## **Barnaderg Cooloo Windfarm Action Collective CLG**

<b>To</b>	<b>The Secretary, An Coimisiún Pleanála - 64 Marlborough Street, Rotunda, Dublin 1, D01 V902</b>
<b>From</b>	<b>The Secretary, Barnaderg Cooloo Windfarm Collective CLG - Cooloo, Moylough, Co Galway</b>
<b>Your Ref</b>	<b>PAX07.323761 – Cooloo Wind Farm</b>
<b>RE</b>	<b>Submission in objection to proposed development</b>
<b>Date</b>	<b>21 November 2025</b>

The Collective refer to the above planning application and advise that the **Barnaderg Cooloo Windfarm Action Collective CLG** (The Collective) wishes to lodge the following submission in objection to the proposed Cooloo Windfarm development, which is located in County Galway in the townlands of Cloondahamper, Cloonascragh, Elmhill, Cooloo, Lecarrow, Dangan Eighter, Lissavalley and Slievegorm. It is a project consisting of 9 wind turbines with the capacity to generate a max of 64.8 MW of electricity to the national grid.

Figure 1

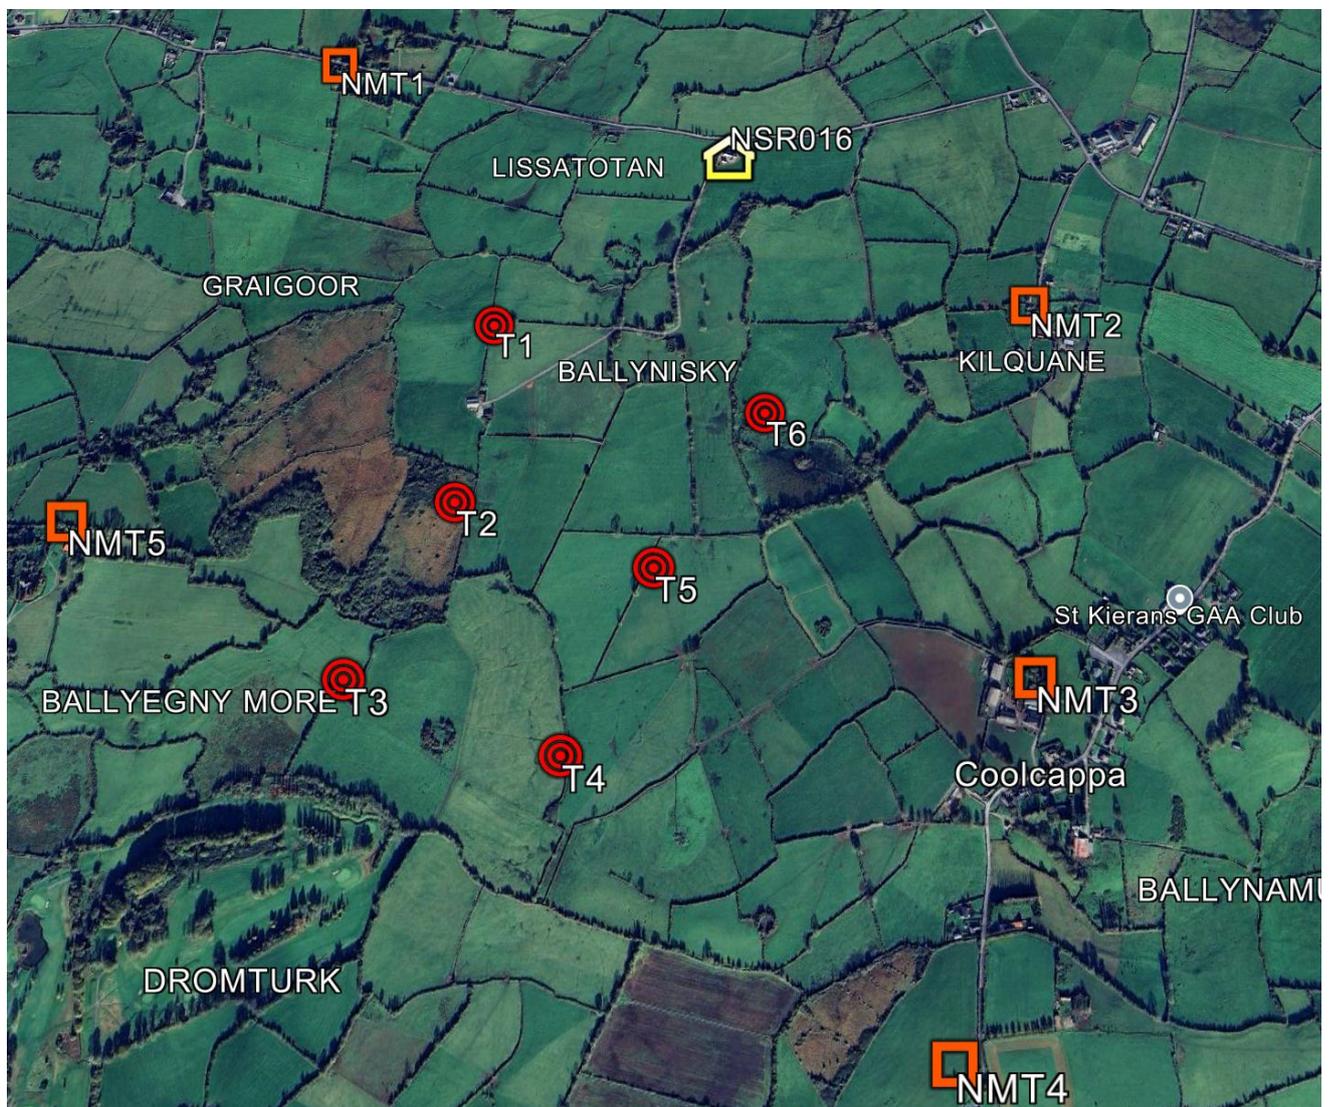
The proposed wind farm development (see Figure 1) is not a Strategic Infrastructure Project that is suitable for assessment by An Coimisiun Pleanála. The application is to be assessed by the Limerick County Council.

Location of nearest dwelling (NSR016), wind turbines (T) and background measurement locations (NMT)

Figure 4

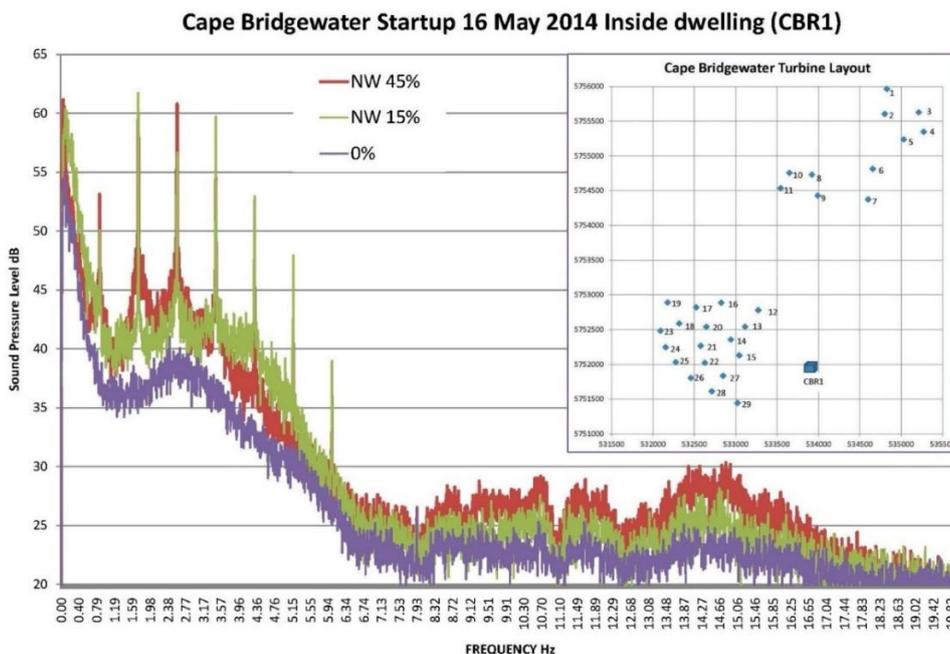
Figure 4 shows the change in infrasound levels near to the Cape Bridgewater wind farm measured inside a nearby stone dwelling during changes in operation from stopped to 15% and 45% power generation.

The NVA references two studies in page 15 and page 16 (11.3.3.9 (1)) that have used the dB(G) filter to assess wind farm ILFN. However, the G-weighting filter attenuates the blade pass pulses and the harmonics associated with those pulses (<5Hz).

**Figure 12: Time History Figure of G-Weighted Sound Pressure Levels for a Wind Farm**

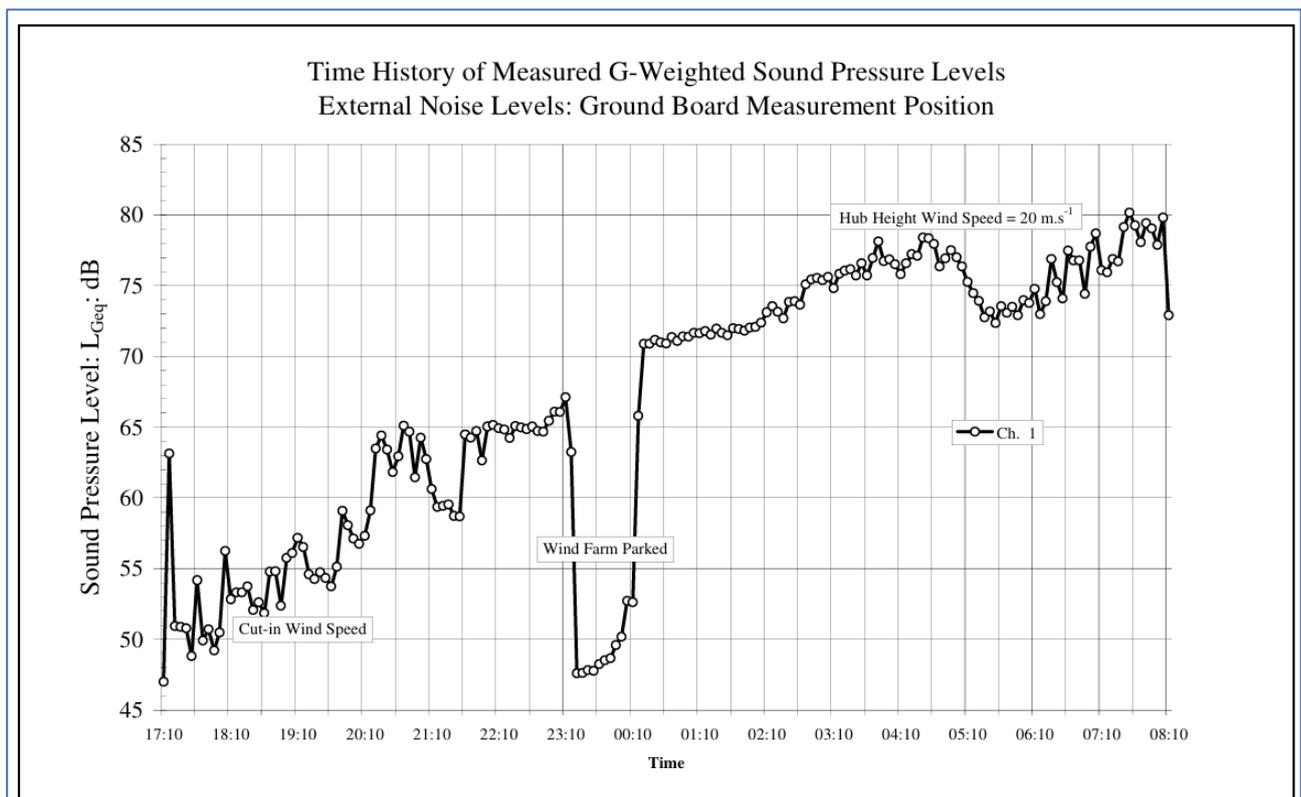
Although the G-weighted filter significantly attenuates the blade pass and associated harmonics from a wind turbine it is worth noting that reference to the 2006 Hayes McKenzie report neglected to show the result of an on/off test in that report, shown below (Figure 12 from reference).

An extract from this report explains that “Wind turbine noise may result in internal noise levels within a dwelling that is just above the threshold of audibility,” that was assumed to be 85 dB(G).

The 2019 Flinders University research changes the threshold of audibility of wind farm noise to 48 +/- 2 dB(G) which would change the conclusion in the Hayes McKenzie DTI report; ‘The measurement of low frequency noise at three UK wind farms’, URN no. 06/1412 from 2006.

**Figure 5**

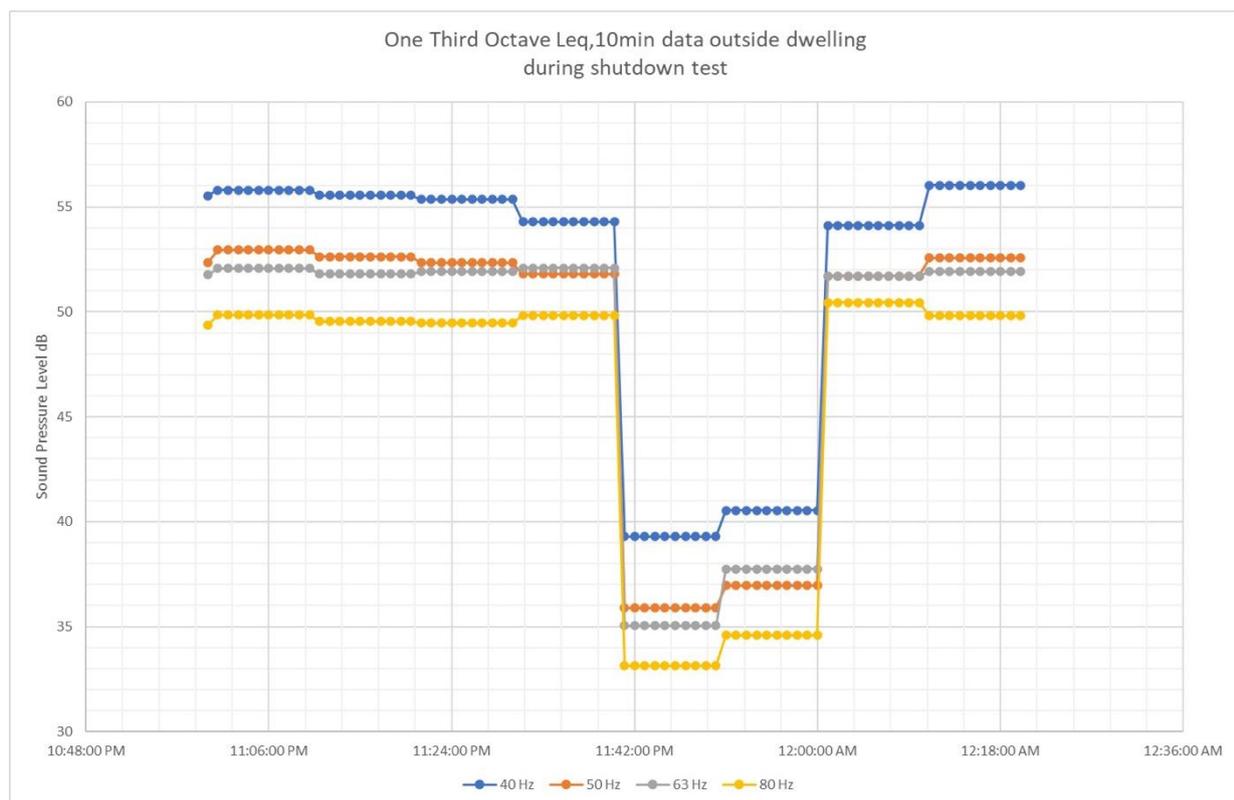
I have recently measured low frequency sound outside a dwelling during on/off testing near to a recently constructed wind farm. Figure 5 shows the results of measurements at the dwelling that is approximately 2 km from the nearest 3.6 MW wind turbine.

The occupants of the dwelling had complained about low frequency noise nuisance from the nearby wind farm and in this instance, the complaints were justified.

The NVA has mistakenly completely dismissed ILFN.

It would be advisable to measure current ambient ILFN at the NSLs to supplement A-weighted Background survey results.
